Submission to The Proposed Amendment (2012) To The Algonquin Provincial Park Management Plan

Submitted by the Algonquin Backcountry Recreationalists

September 11th, 2012

B1 - 2012

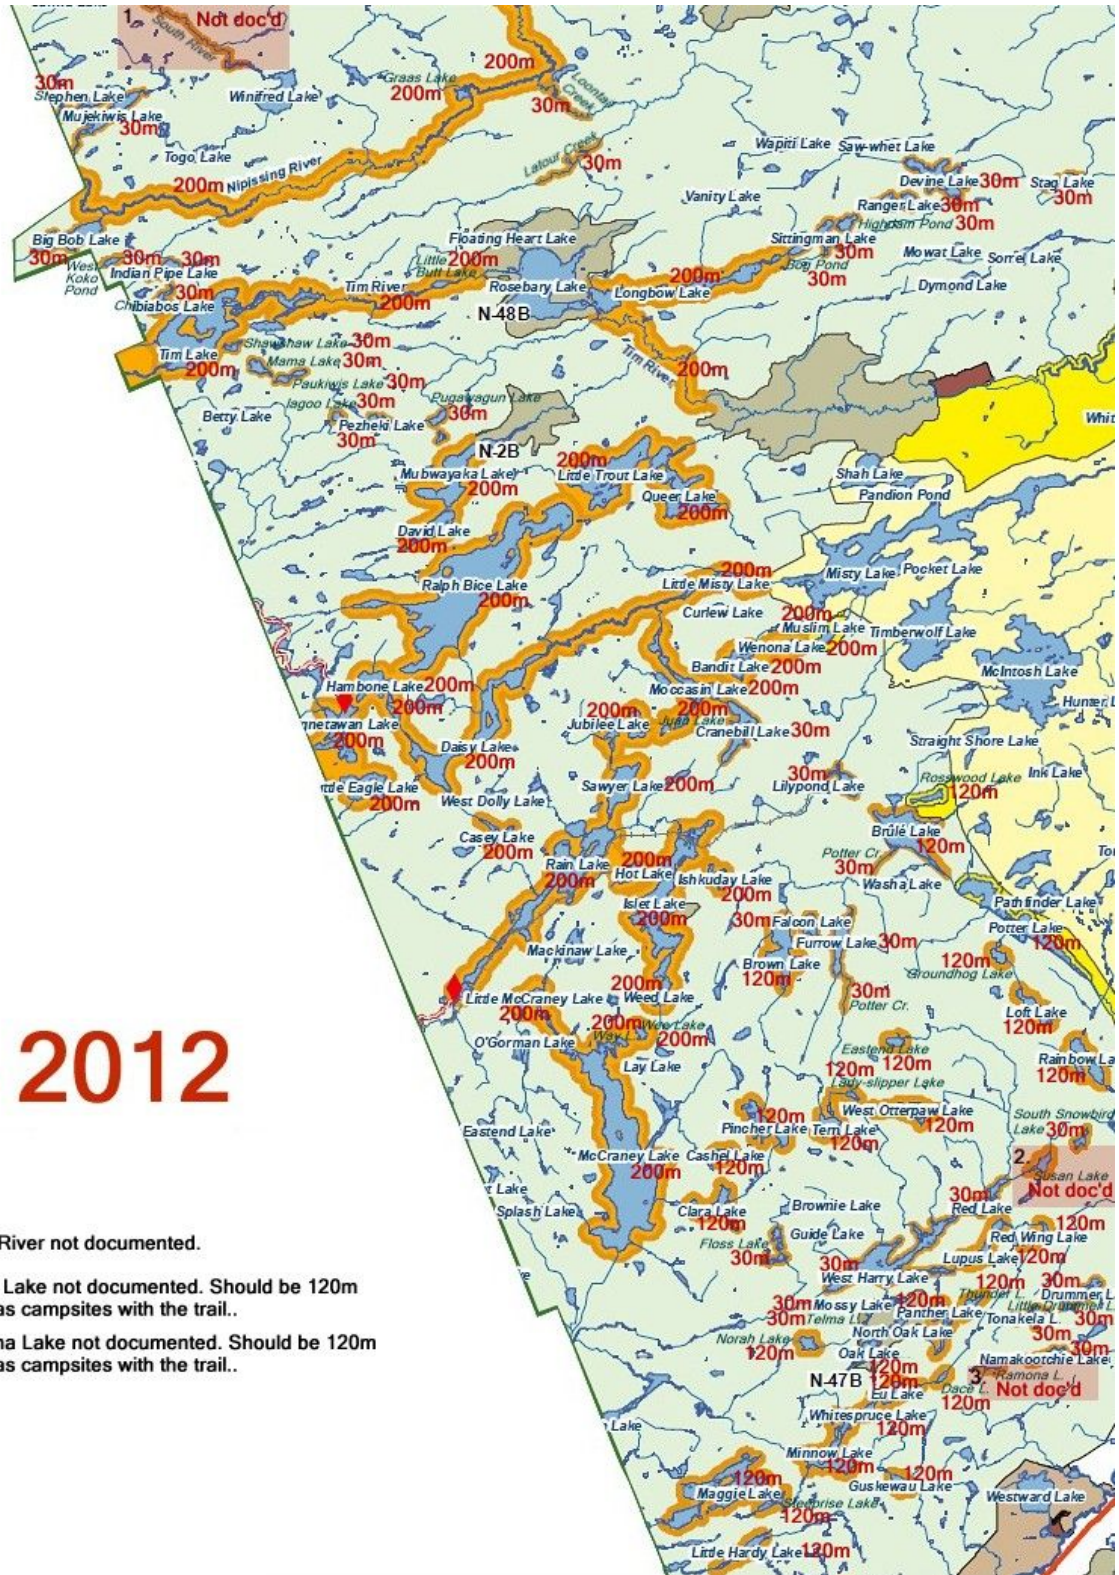
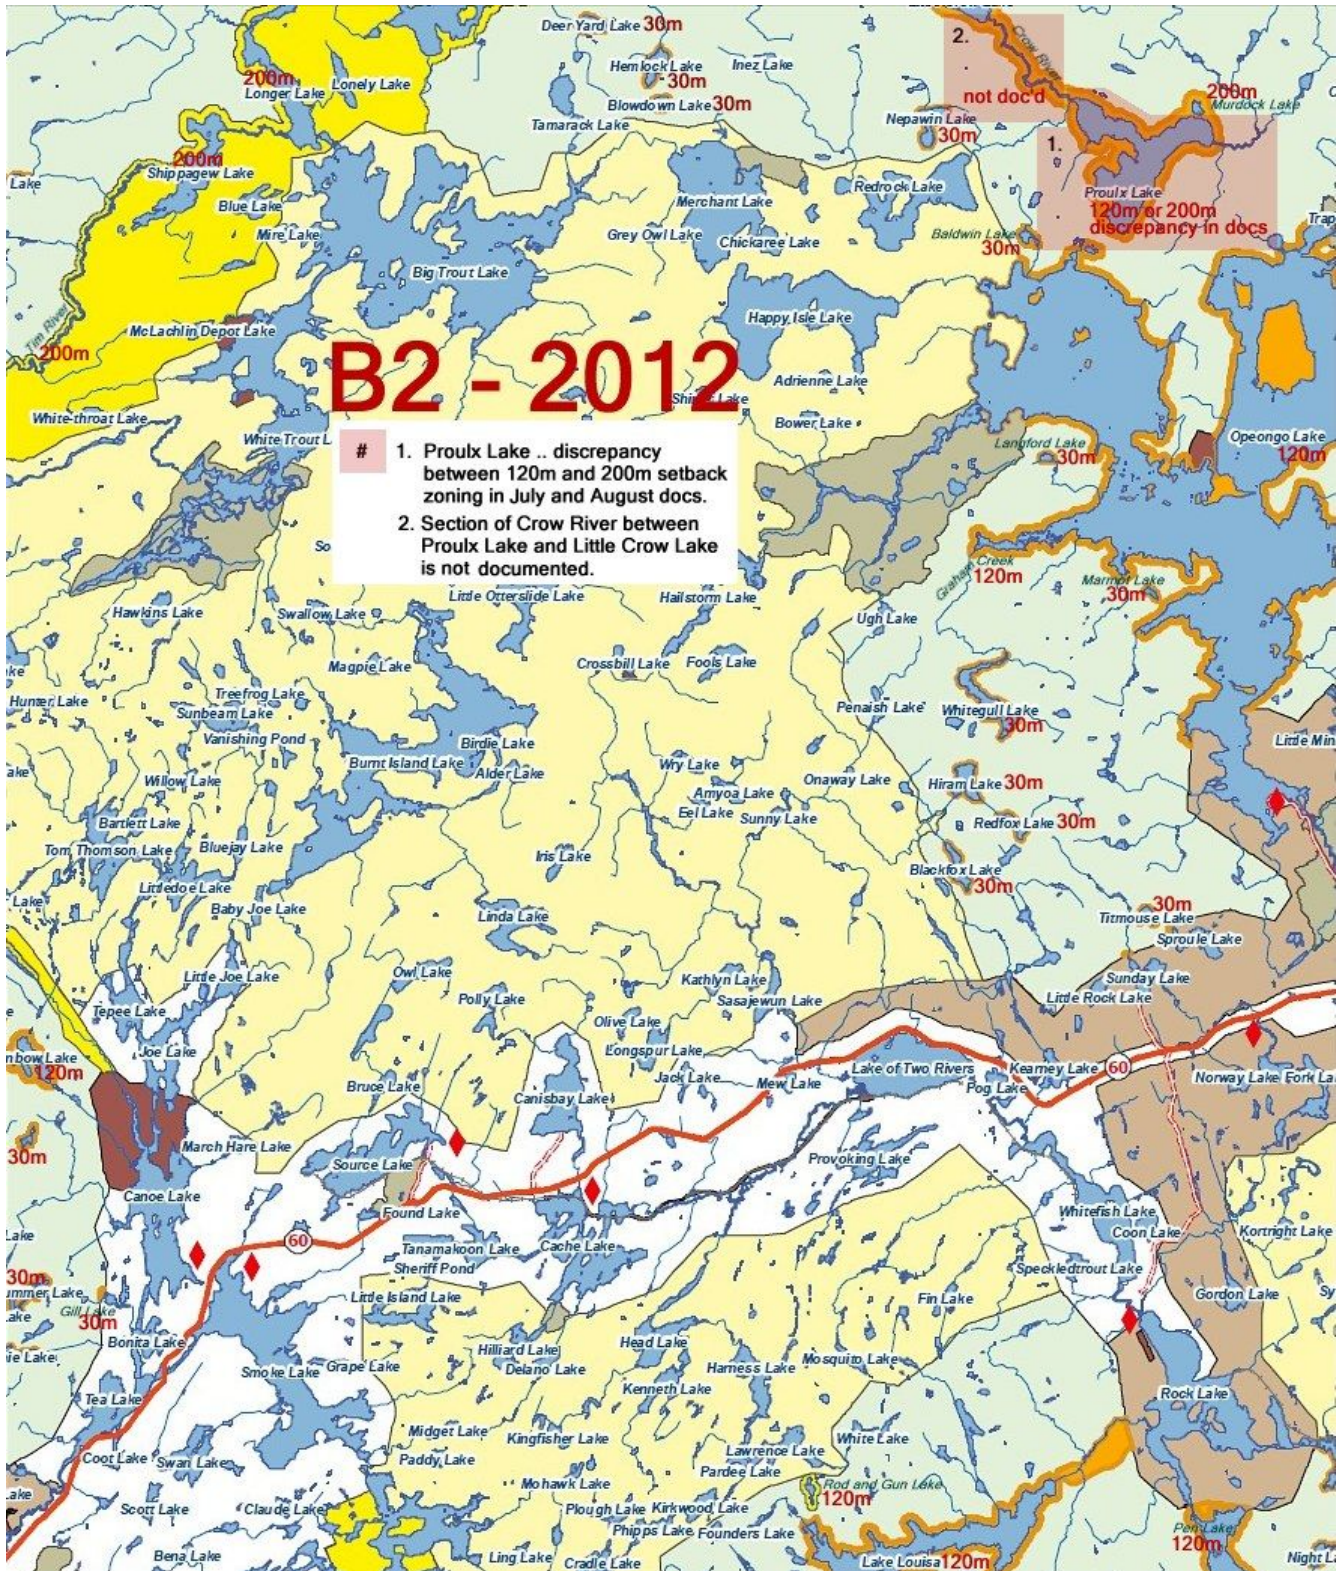
Map B1 – 1. South River .. while it is illustrated on the Figure 3b Map as having a “shallow setback zoning”, the zoning's depth is not described in either of the other two documents. (also on Map B1)

Map B1 – 2. Susan Lake .. While this lake has a setback zoning illustrated on the Figure 3b Map, its setback zoning depth is not described in either of the other two documents.

Map B1 – 3. Ramona Lake .. While this lake has a setback zoning illustrated on the Figure 3b Map, its setback zoning depth is not described in either of the other two documents.

1. South River not documented.
2. Susan Lake not documented. Should be 120m as it has campsites with the trail..
3. Ramona Lake not documented. Should be 120m as it has campsites with the trail..

Concern 12: Since Susan Lake has campsites associated with the Western Uplands Backpacking Trail , the ABR maintains it should have a 120 meter setback zoning.

Concern 13: Since Ramona Lake has campsites associated with the Western Uplands Backpacking Trail , the ABR maintains it should have a 120 meter setback zoning.

C1 - 2012

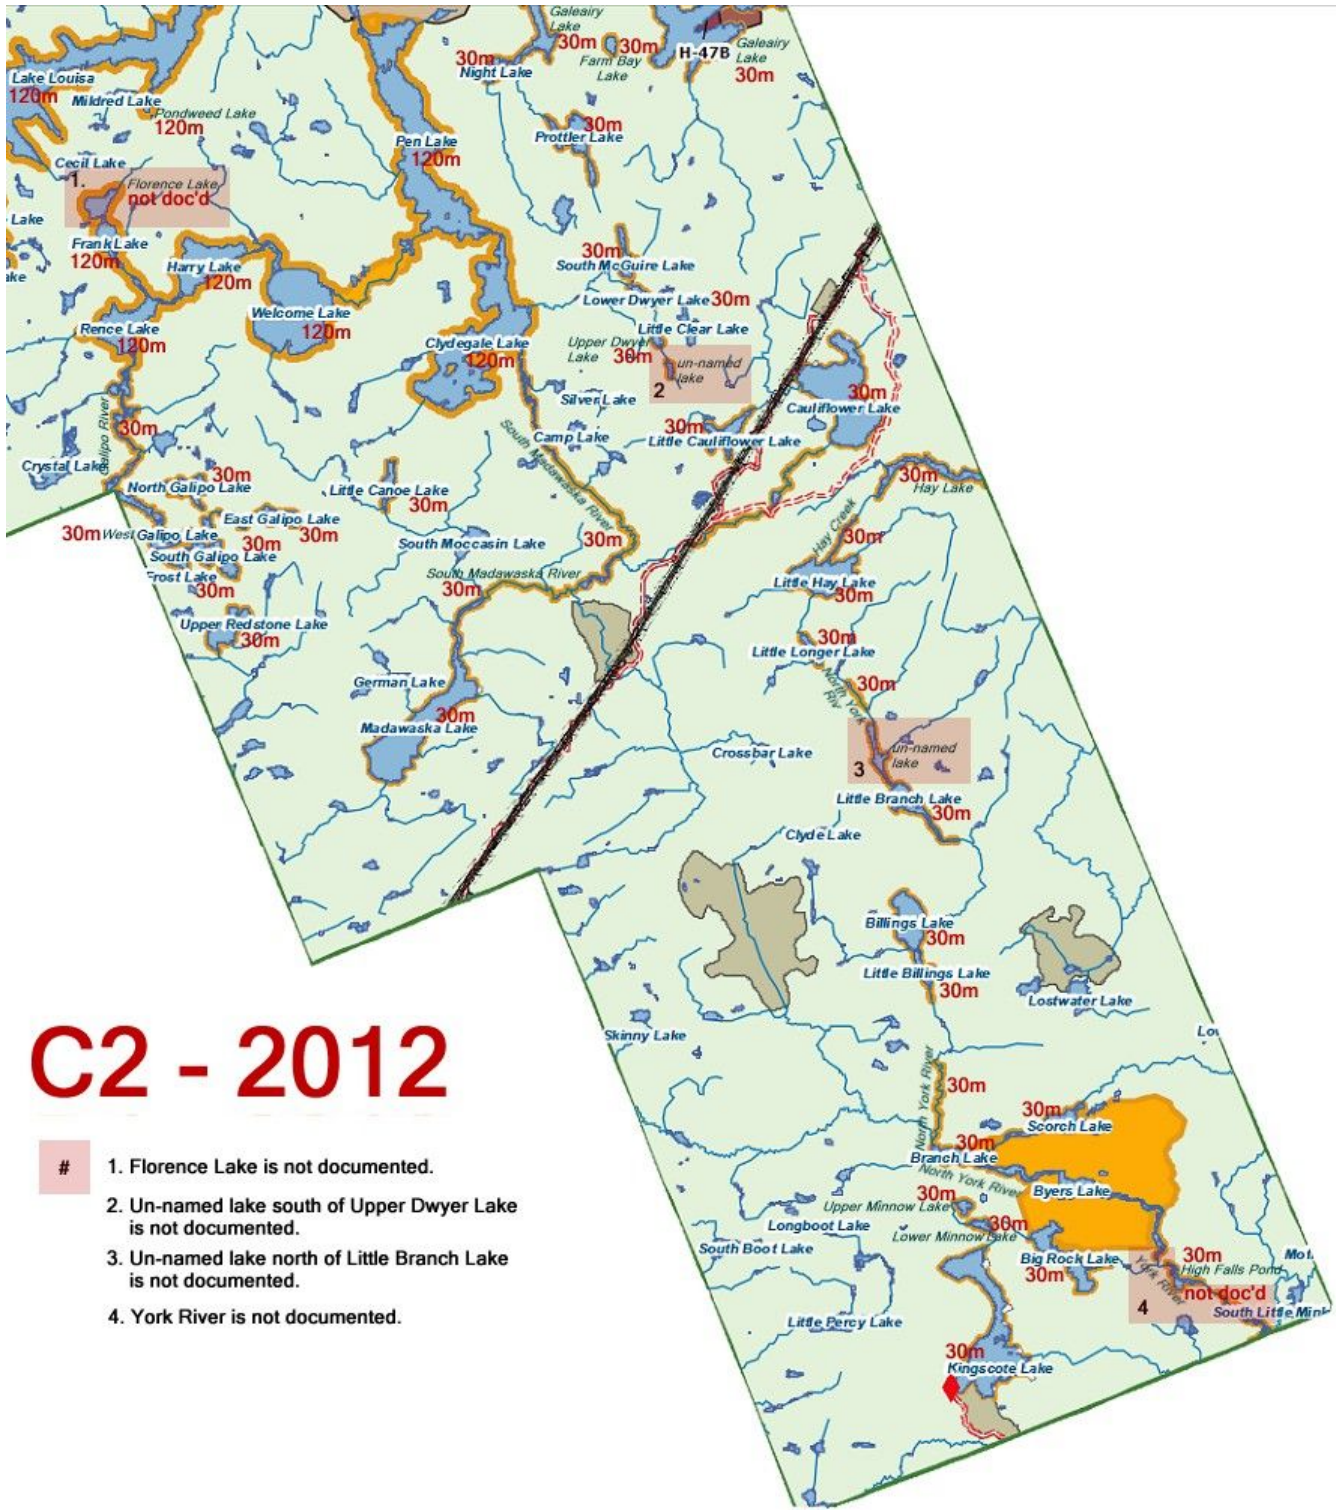
- # 1. North Lemon Lake not documented.
- 2. Un-named lake on Hollow River, not documented.
- 3. Hollow River not documented.

Map C1 – 1. North Lemon Lake - while it is illustrated on the Figure 3b Map as having a setback zoning, the zoning's depth is not described in any of the documents.

Map C1 – 2. Un-named lake – while an un-named lake south of Loader Lake has a setback zoning illustrated on the Figure 3b Map, the zoning's depth is not described in any of the documents.

Map C1 – 3. Hollow River – while it is illustrated on the Figure 3b Map as having a setback zoning, the zoning's depth is not described in any of the documents.

Concern 16: The ABR maintains that North Lemon Lake deserves a 120 meter setback zoning, in keeping with the rest of the canoe route lakes it is joined to.

Concern 17: The ABR maintains that this lake (which has two campsites) deserves a 120 meter setback zoning, in keeping with the rest of the canoe route lakes it is joined to.
